TE Connectivity

Product Change Notification: E-20-002873

UNIVERSAL M-N-L SOCKET

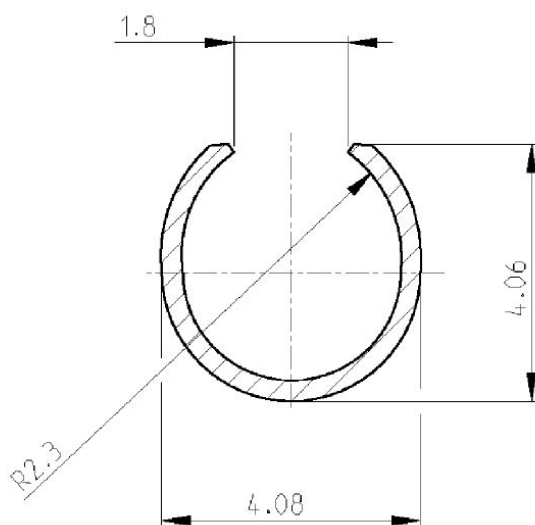
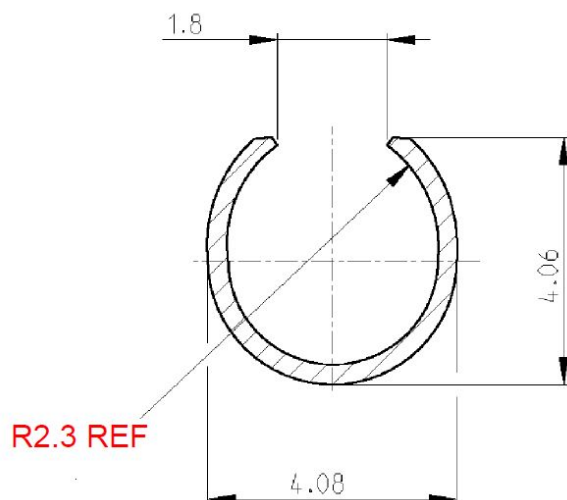
The drawings for the listed part numbers have been modified to correct following; Before: R2.3 After: R2.3 REF
